CALIFORNIA COASTAL COMMISSION

MEMORANDUM

Subject: **Addendum to Commission Meeting for Friday, March 13, 2009**
North Coast District Item F13a, CDP Amendment No. 1-90-104-A2
(City of Eureka – PALCO Marsh Enhancement Plan Phase 1A)

ADDENDUM TO STAFF RECOMMENDATION

Figure 1. Overview of northwest outlet from Palco Marsh to the Tidal Channel. Note the former Eureka Plywood Mill drains to the drainage swale in the upper left of the photo. The bay is at the south end of the Tidal Channel, about 800 feet beyond the lower left corner of the photo.

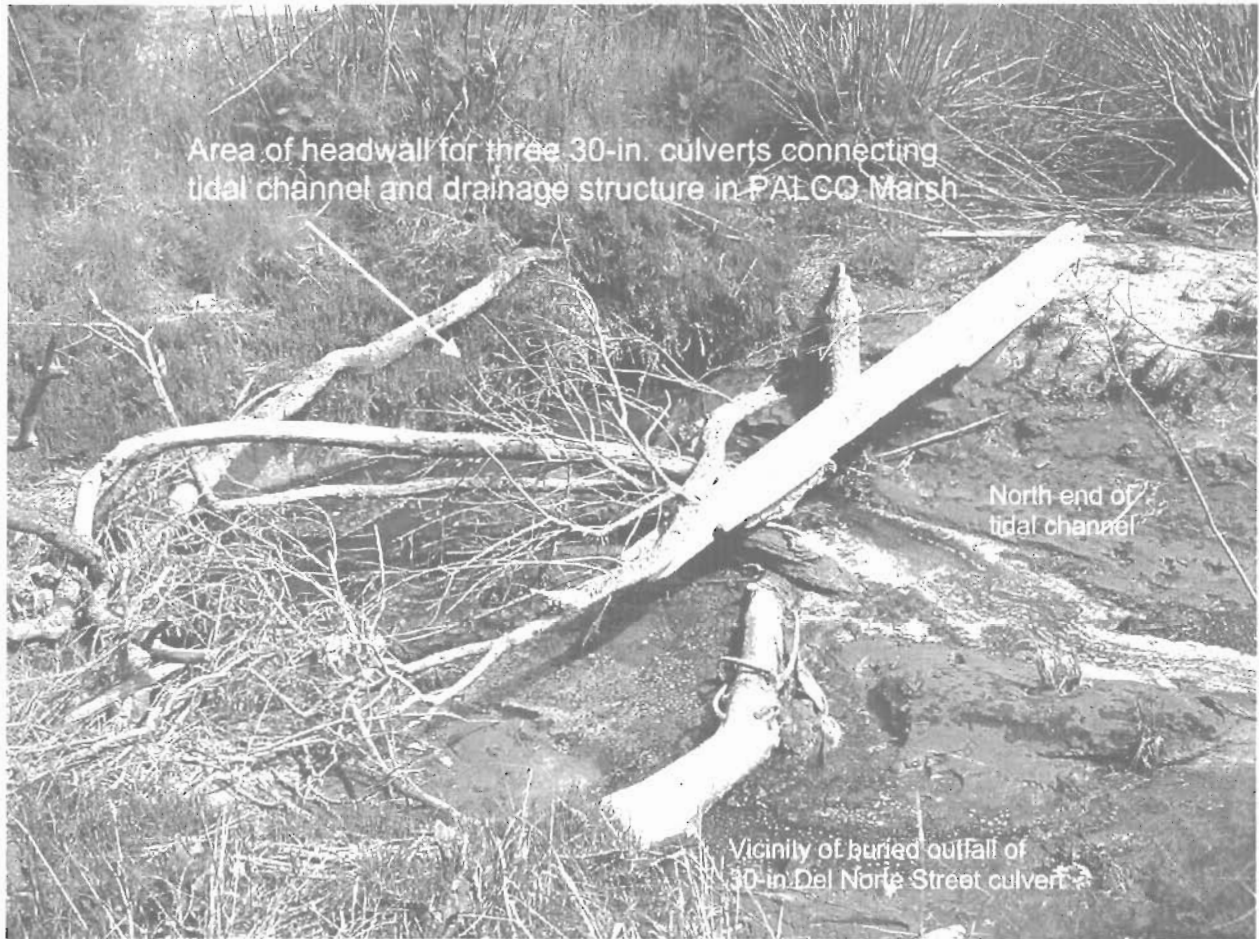
Dioxin samples were also taken in the tidal channel that drains from the Eureka Plywood Mill (EPM) site to Humboldt Bay, by both Humboldt Baykeeper and RWQCB staff. This tidal channel also connects the northwest end of Palco Marsh to the bay, through three old culverts (Figure 1), but those culverts have been blocked by sediment and debris and water flow is impeded (Figure 2). A sample taken by Humboldt Baykeeper staff at the north end of the tidal channel (near the outlet from the EPM and the blocked culverts to Palco Marsh), showed a total dioxin level of 46.04 pg/g TEQ, clearly elevated above ambient levels in the bay, but much reduced from the levels found at the former plywood mill. Regional Water Quality Control Board staff also took dioxin samples at ten locations around Humboldt Bay in June 2007. Their

resuspend significant amounts of contaminated sediments and keep them suspended long enough to convey them through the culverts into Palco Marsh. Typically outgoing flows from sloughs have more ability to resuspend sediments than incoming tides, due to the force of gravity and concentration of the outgoing flows. The tidal channel occurs behind a long spit of land and is sheltered from wind and waves that could keep sediments suspended on incoming tides (see Figure 3).
